# PROPOSED NUCLEAR DISPOSAL FACILITY AT CHALK RIVER, ON

Comments on the Licence Amendment -  
Required Approvals for Construction of the Near Surface Disposal Facility (NSDF) at the  
Chalk River Laboratories (CRL) site (CMD 22-H7)

April 11th, 2022

**Figure 1 - Chalk River / NSDF Surface Water Monitoring Stations**

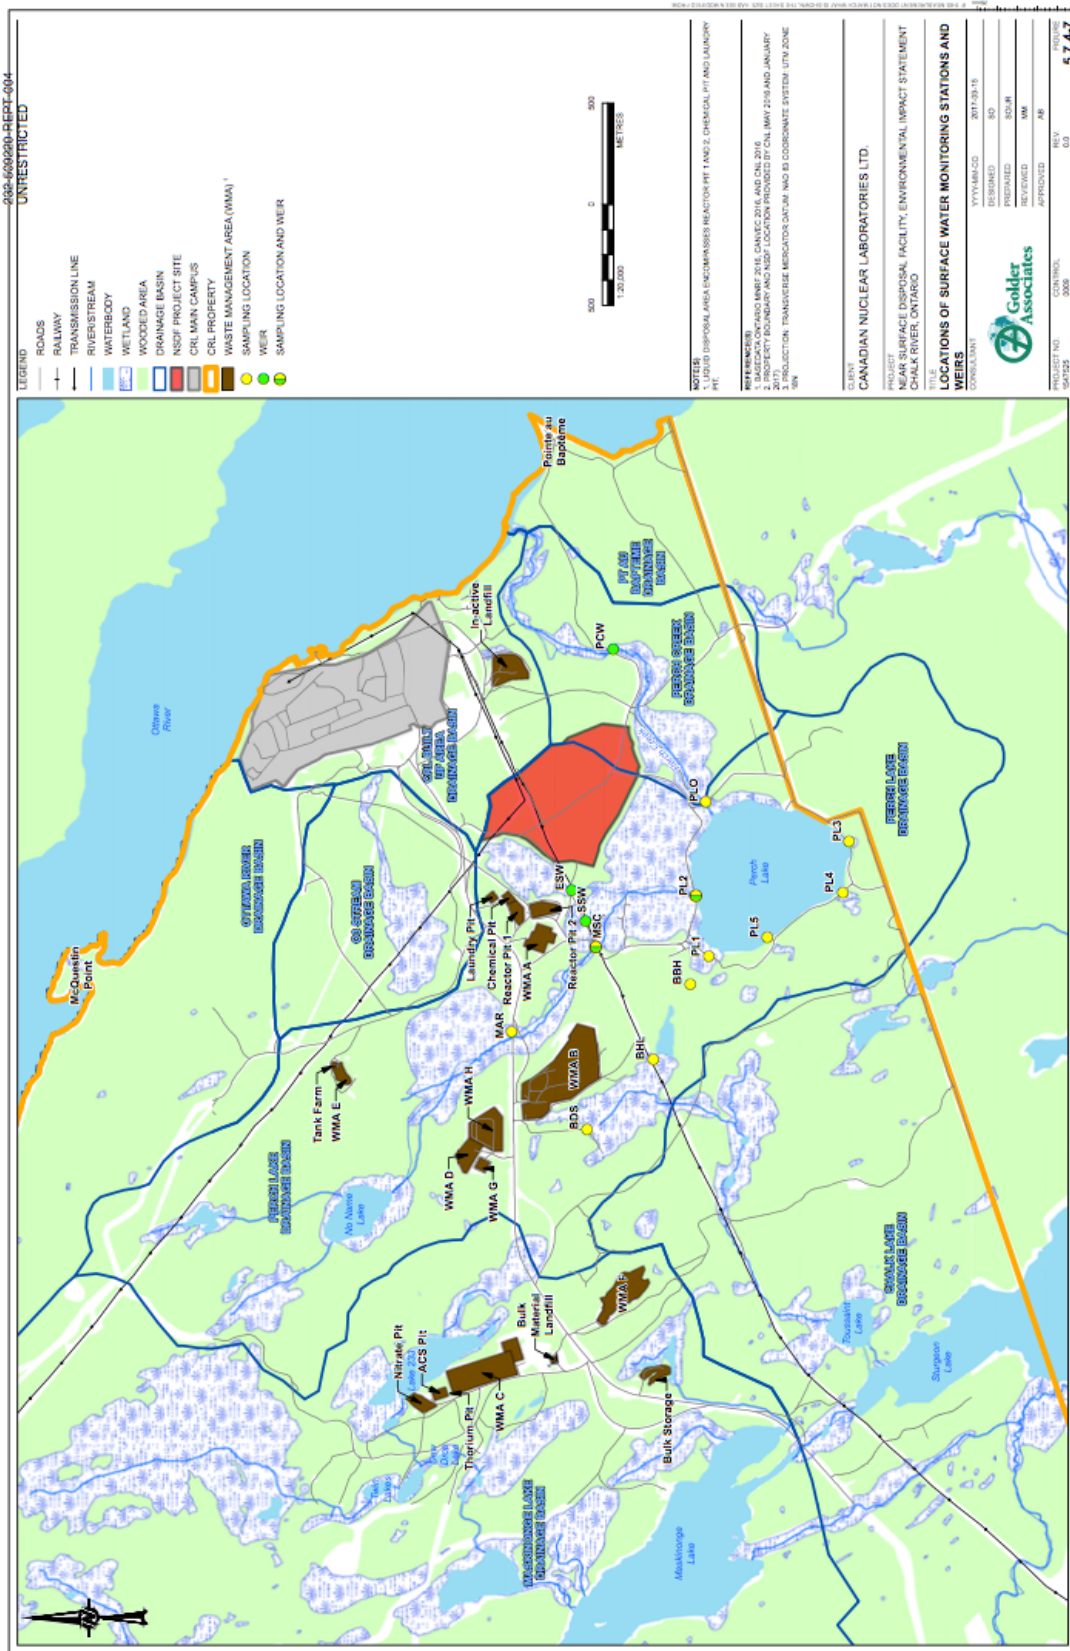
<b><u>Monitoring Locations</u></b> (see Figure 1 map on next page)	<b><u>Tritium Levels</u></b>	<b><u>Reference</u></b>
Background Tritium Levels in Undeveloped NSDF area	48 to 399 Bq/L	Tables 5.3.2-5 and 5.3.2-6
Tritium Levels in Groundwater in East Swamp WMAs	no disclosure provided in final EIS	
East Swamp Weir (ESW)	286 to 348 Bq/L	Table 5.7.4-8
Perch Lake Inlet (PL2)	1,354 to 3,249 Bq/L	Table 5.7.4-8
Perch Lake Outlet (PLO)	1,367 to 2,780 Bq/L	Table 5.7.4-8
Perch Creek - Weir (PCW)	2,056 to 4,233 Bq/L	Table 5.7.4-8

For any other parameter considered in the final EIS, the fact that background levels in the watershed are elevated would not be a concern. This is because the effluent quality discharge targets adopted in EIS Table 3.4.2-2 and Table 3.4.2-3 are based on regulatory limits for each of the parameters being considered - except tritium.

It appears that the proponent has little choice in the matter as a significant proportion of the NSDF's intended waste stream is very high in tritium, and there is no way to remove tritium from the WWTP effluent. Fortunately the ecological risk benchmark for tritium is 17,400,000 Bq/L - almost 50 times higher than the effluent discharge target of 360,000 Bq/L. This provides a massive factor of safety for downstream aquatic species.

The question arises as to why the Provincial Water Quality Objective (PWQO) for tritium has been set at only 7,000 Bq/L - as normally the PWQO are established to protect aquatic life.
